**MCLAREN BACKUP GENERATING
FACILITY PROJECT**

Docket No. 17-SPPE-01

STAFF'S RESPONSE TO COMMENTS, RESPONSE TO MOTION TO DISMISS, RESPONSE TO MOTION FOR NEW SCHEDULE

Figure 1

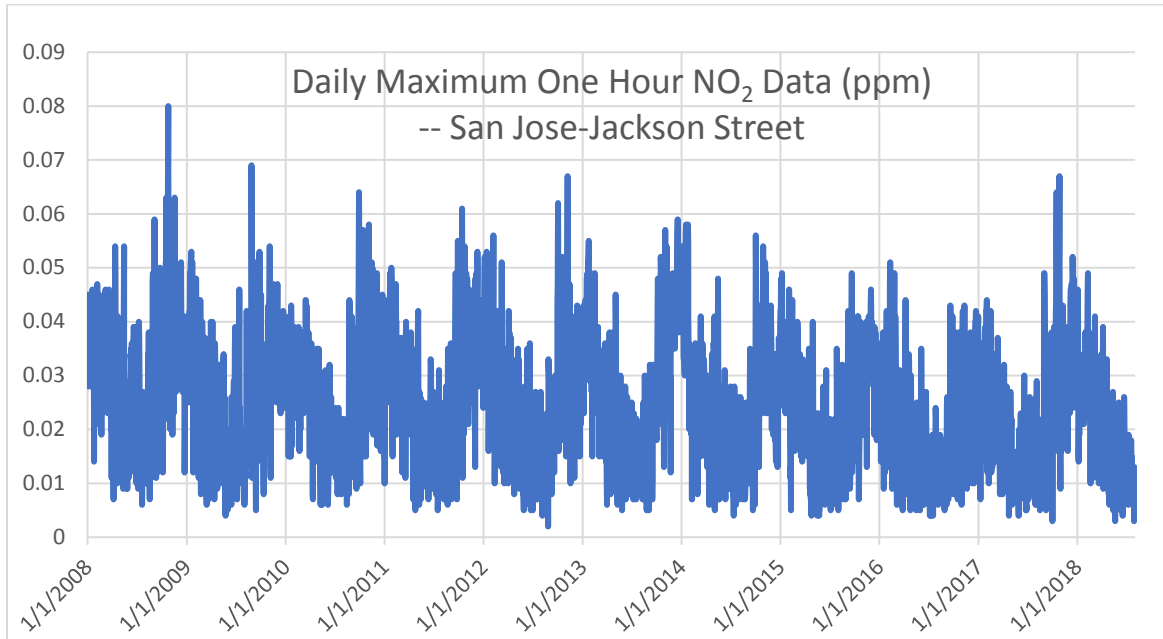
Staff looked at a close, downwind ambient air monitoring station for hourly NO₂ values over the last 10 years (See Figure 1). There are about 120 data centers in the Bay Area, many of which are in the south bay (about 40 are in Santa Clara alone). The Jackson Street monitoring station could see spikes in NO₂ concentrations from widespread data center emergency engine use. While Staff does not know how often or which data centers tripped such that emergency engines ran during that time, the data in Figure 1 shows a distinct seasonal pattern (NO₂ levels tend to spike in the fall months, where days are short and local weather patterns are fairly stable) more so than spikes from any non-uniform utility outage leading to concurrent back-up engines operations and increased NO₂ levels.

The federal standard is 100 ppb (parts per billion, or 0.100 parts per million, the units used in the graph below). The monitoring data shows one reading up to 80% of the federal standard and a slight overall downward trend. The monitoring station is also downwind from the San Jose airport.

Figure 2

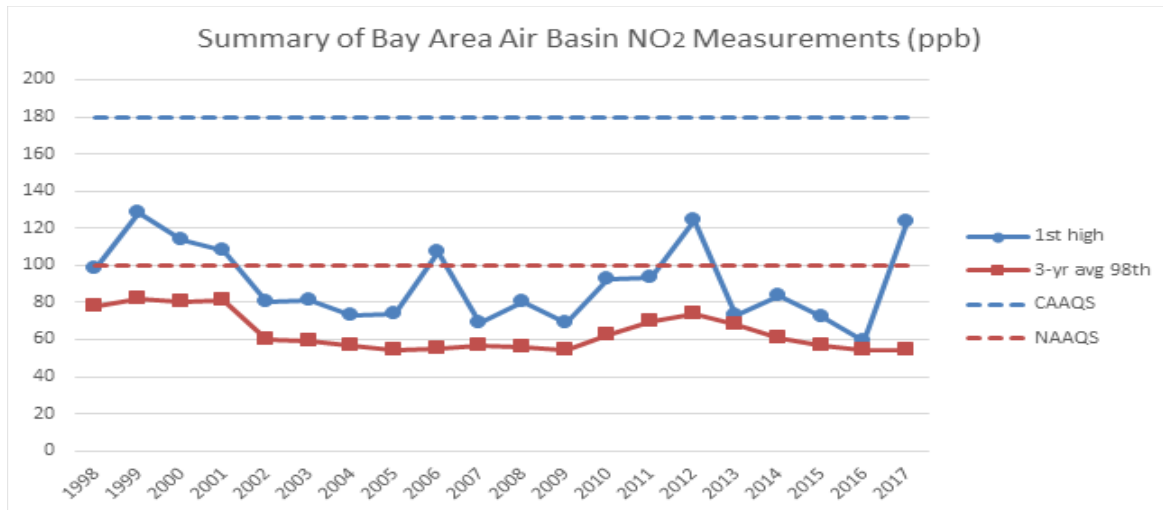
Staff compiled a summary of NO₂ values, for both the state and federal standards, shown in Figure 2. This graph is expressed in parts per billion (ppb). The Bay Area NO₂ values appear to be trending down (see the red federal line), despite a rebounding economy, population increases, and the fact that the Bay Area has northern California’s oil refineries. The trend in the state standard is less clear. But the Bay Area values are well below both the state and federal health-based ambient air quality standards. It

would appear that the build out of data centers in the Bay Area, and Santa Clara specifically, has not adversely affected local and regional hourly NO₂ trends.

Figure 3

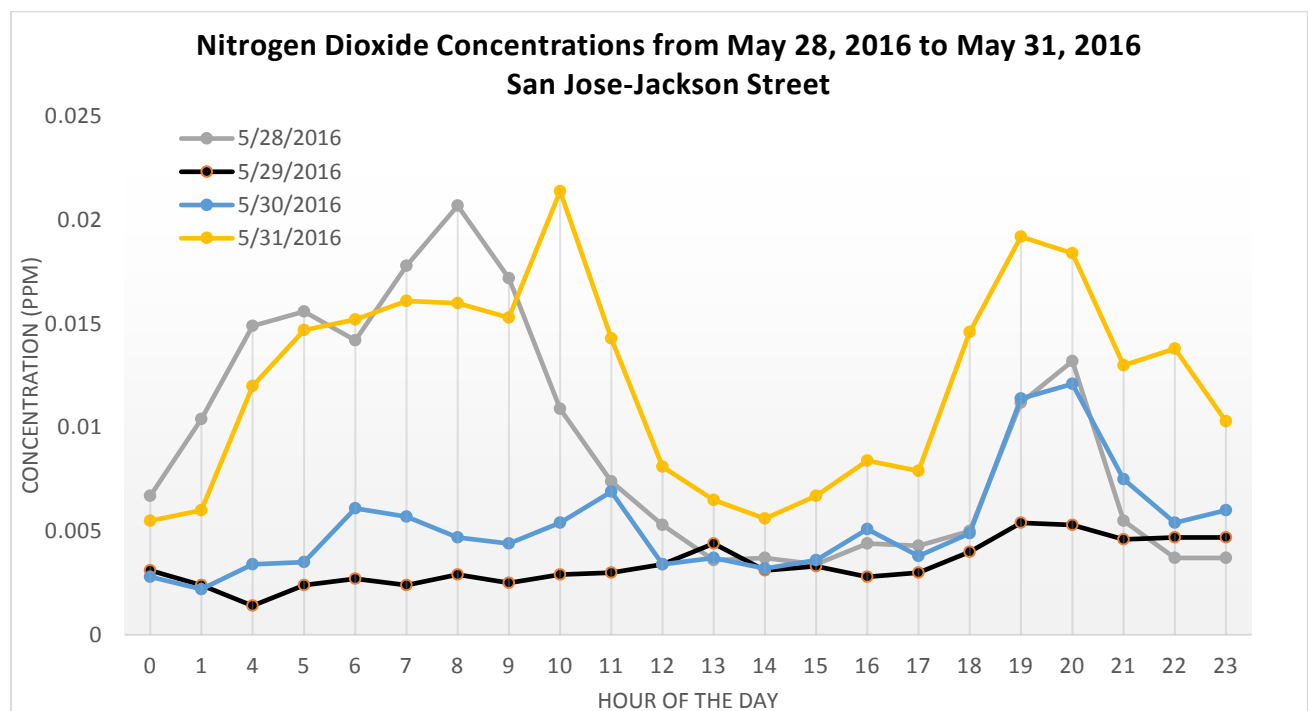
Staff reviewed ambient air quality data for the nearest monitoring station (San Jose—Jackson Street), located approximately 4.5 miles southeast of the Santa Clara Campus site. The downwind NO₂ and ozone concentrations did not change appreciably before, during or after the outage and the potential operation of some, or numerous, data center emergency engines. Neither the NO₂ concentrations nor the ozone concentrations approached their respective ambient air quality standards on May 29, 2016 and likewise these standards were not approached on May 30, 2016 or May 31, 2016. **Figure 3** below shows NO₂ concentrations the day before, during (see dark line) and immediately after that event. Note that NO₂ concentrations are well below the one-hour California ambient air quality standard of 0.18 ppm. These data indicate that the operation of these six engines at Vantage Santa Clara Data Center 1, and potentially other engines at other data centers, did not lead to increases of ambient emissions. However, NO₂ is an ozone precursor, and because ozone requires some time to form, the San Jose--Jackson Street monitoring site might show an ozone impact from this event.

Figure 4

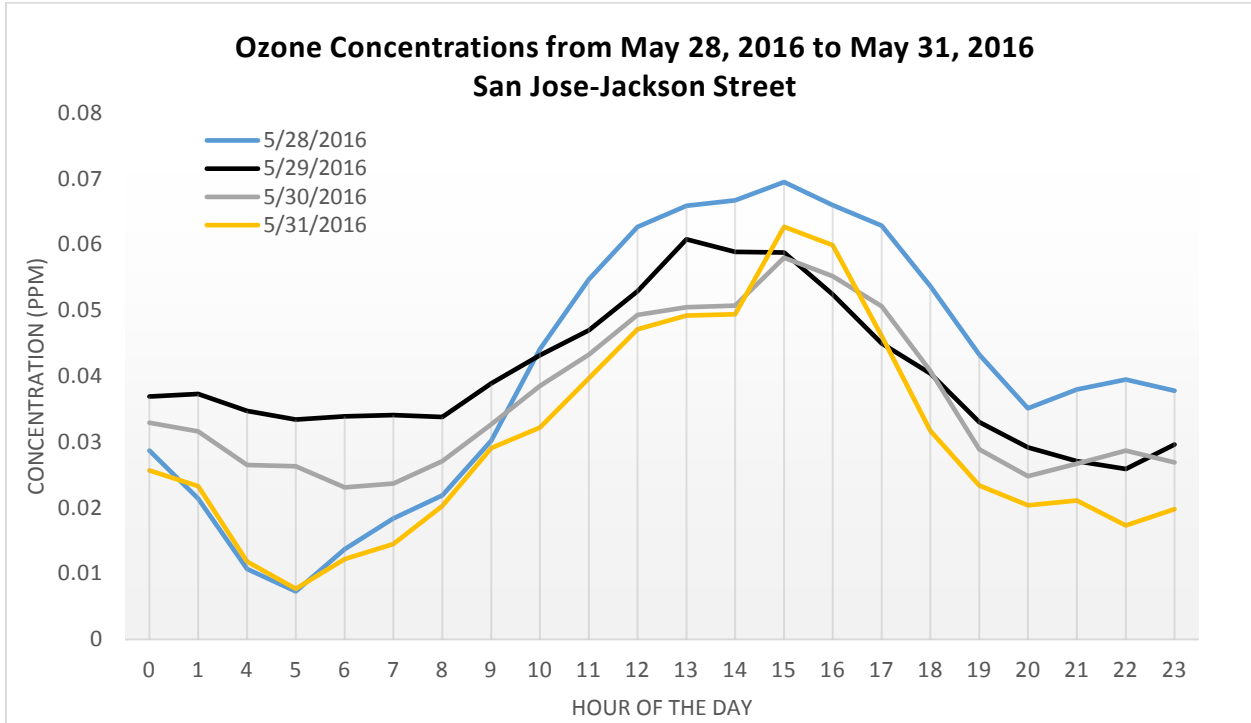
Figure 4 below shows corresponding ozone concentrations over the same time period. Note that these data also remained below the California 1-hour ozone standard of 0.09 ppm. Ozone levels for the two days after the event (May 30, 2016 and May 31, 2016) were actually lower than the day before the event (May 28, 2016). Again, data for the day of the event are shown in black.
